# PCN – Product Change Notification

Document No	PCN-A-080605	Revision	1.0		
-------------	--------------	----------	-----	--	--

**ECN Topic: New 12.1 inches Rear Mount Dimension**

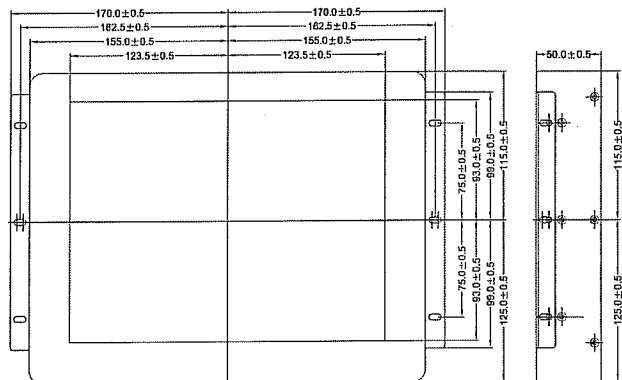
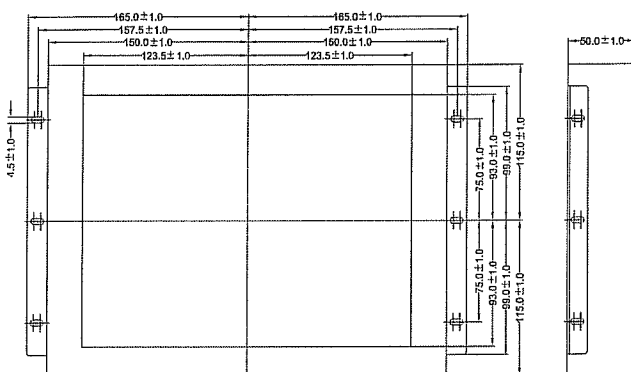
We will release new dimension for 12.1" Rear Mount LCD. The dimension of mechanical will change from 300 x 230 x 50 mm to 310 x 240 x 50 mm and change the position of OSD to back side.
